Appendix B

Emergency Preparedness Significance Determination Process

Emergency Preparedness Significance Determination Process

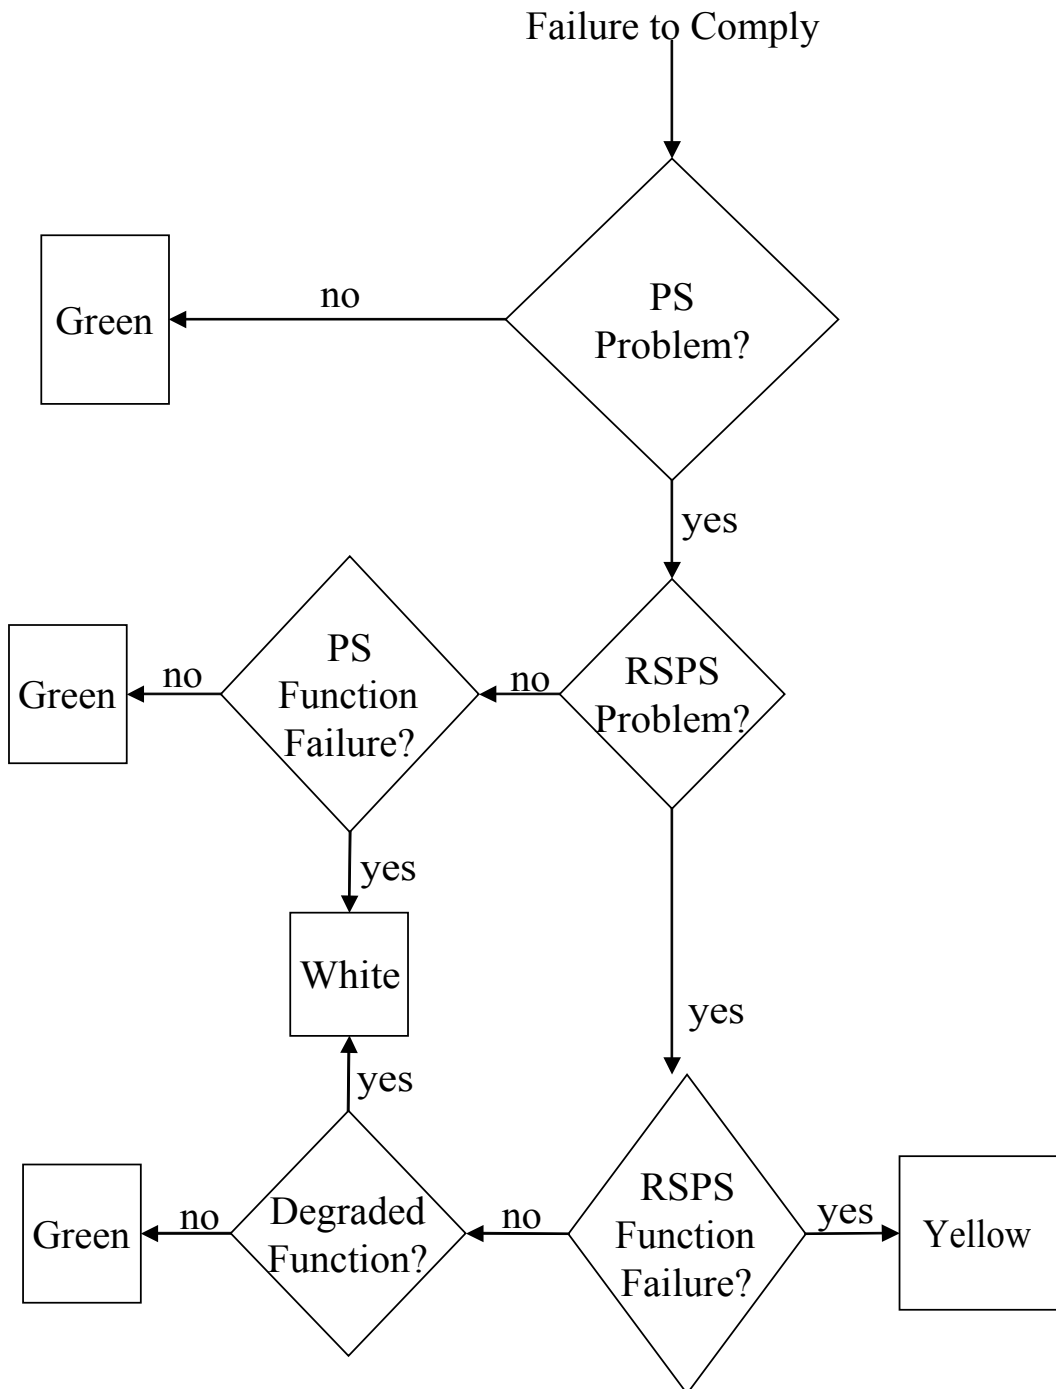
**Proposed Revision to EP SDP
Failure to meet Regulatory Requirement
(This line replaces left line sheet 1 Failure to meet Regulatory Requirement)**
